Report Draft Issue Date: March 22nd, 2021

This report is the deliverable for **Task 1**.

This report is the deliverable for the first of three tasks in the Cost and General Assessment reports to the Board.

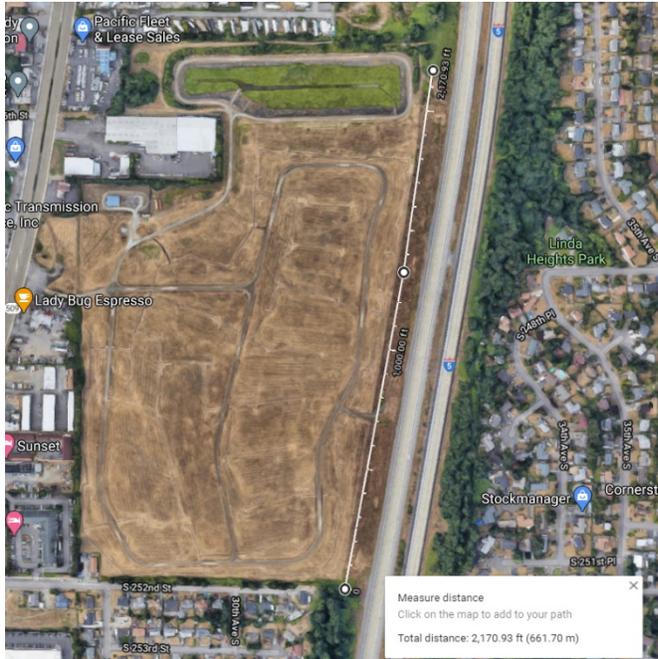
- 42,877RF ST3 (2016) to 65,859RF Phase 1 (2019) then to 65,233RF Phase 2 (2020) of Hazmat Removal and Mitigation.
- 24% increase in unit rate from ST3 (2016) to Phase 2 (2020).
- ST3 (2016) to Phase 1 (2019) had significantly change in RF calculation. Large increase Heavy Allowances into Phase 1 (2019). Then reversing back slightly at Phase 2 (2020) into the Medium category.

MIDWAY LANDFILL

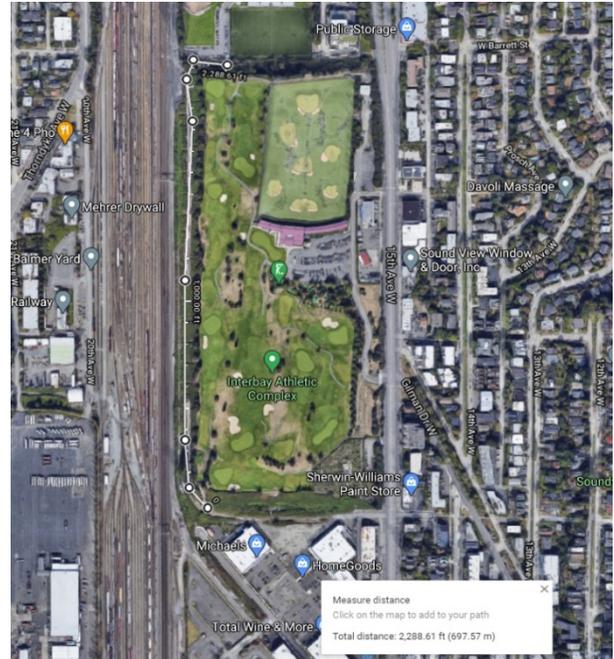
- » The length of impacted area due to the routing of the ST line is similar. Roughly 2,200LF.
- » We know at Midway the ST line will be on grade vs at Interbay aerial station, but future contractor will need access to work.
- » Roughly 200,000T of landfill soils was disposed of from the Midway site.
- » Replacement of 200,000T of exported material can add \$30/T = \$6M in addition to the disposal costs.
- » Total \$11M disposal + \$6M import = \$17M potential add.

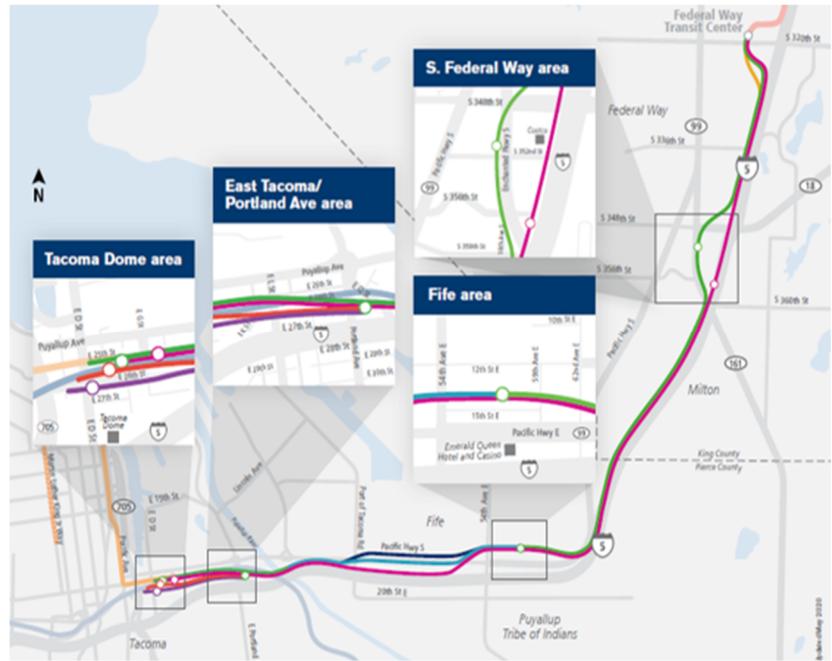
- New item of 1 LS was added in Phase 2 (2020) for 40.04, adding \$13M at Puyallup River Crossing for clear span crossing (Tribes Ceremonial Grounds, Water Quality and Fishery Impacts).
 - 2000LF x both sides of Puyallup River @\$300/LF, equates to \$1.2M.
 - 9 acres of site disturbance around Puyallup River. Assuming worst case scenario, 1:1 ratio, at \$1M per acre which equates to \$9.0M.
 - Total cost equates to \$10.2M plus 30% contingency for Design, PM, Survey and Monitoring. \$13.0M in Phase 2 (2020) appears adequate for the Environmental mitigation at this site.

Operations and Maintenance Facility South – Midway Landfill (Platform)

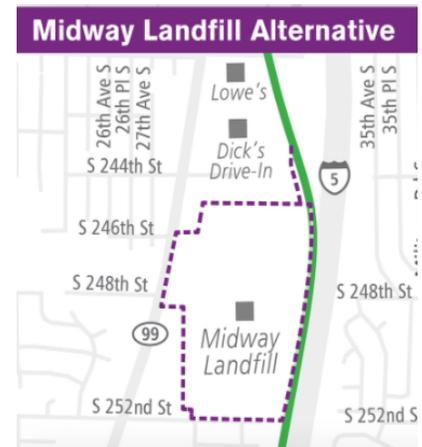
- This option was not part of ST3 (2016).
- Estimating methodology (Light, Medium, Heavy) and unit rates differed between the estimates.
- Route Feet increased by 159% from Phase 1 (2019) (2,350RF) to Phase 2 (2020) (6,081RF).
- Project cost increased by 2,425% from Phase 1 (2019) (\$1.5M) to Phase 2 (2020) (\$38.3M).
- Scope of work allowance changed, thus increase in unit rate, adding \$2.5M in Phase 2 (2020).

- » 40.03 Phase 1 (2019) – 2,350RF was priced as Heavy with a unit rate of \$493.28/RF.
- » 40.03 Phase 2 (2020) – 1,747RF was priced as Light with a unit rate of \$160.72/RF and 4,334RF was priced as Heavy with a unit rate of \$579.14.
- » 40.04 Phase 1 (2019) – 2,350RF was priced as Light with a unit rate of \$152.27/RF.
- » 40.04 Phase 2 (2020) – 4,334RF was priced as Light with a unit rate of \$131.90/RF and 1,747RF was priced as Medium with a unit rate of \$369.93.

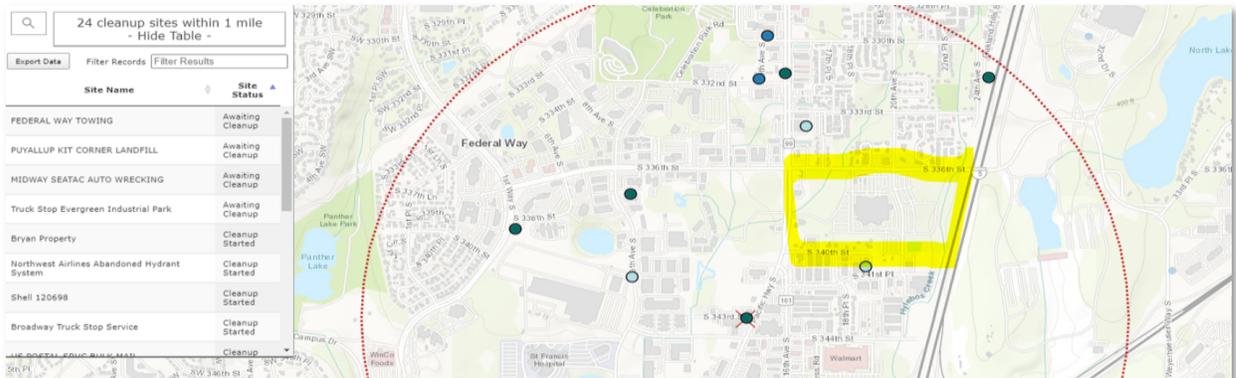
- Does WSDOT has wetland/mitigation bank in the neighborhood that can be used?

▪ **SCC 20 – Stations**

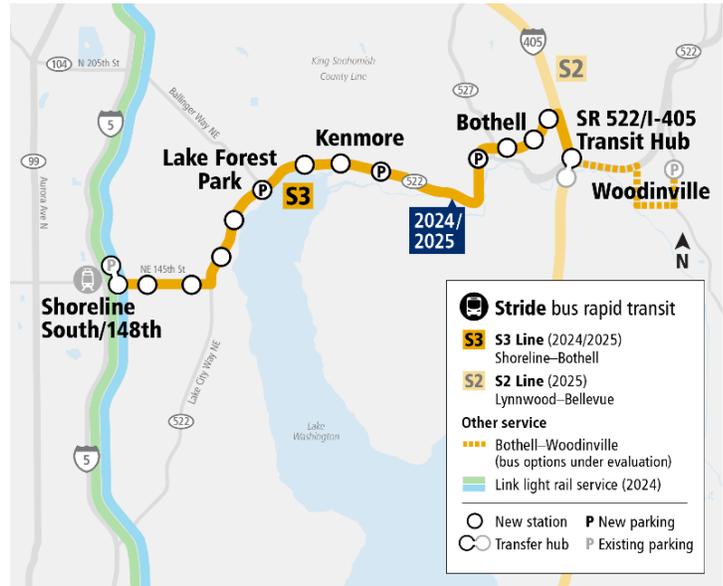
- Station costs were assessed and proved to be in alignment with regional costs.
- Parking stall count increased 40% from Phase 1 (2019) to Phase 2 (2020), and costs increased 22%.
- Parking Garages vary from \$63k to \$74k in direct construction cost per stall, this should be analyzed further for concurrence (expectation is around \$50k in cost), which would realize a savings of \$13M to \$24M on the garages.
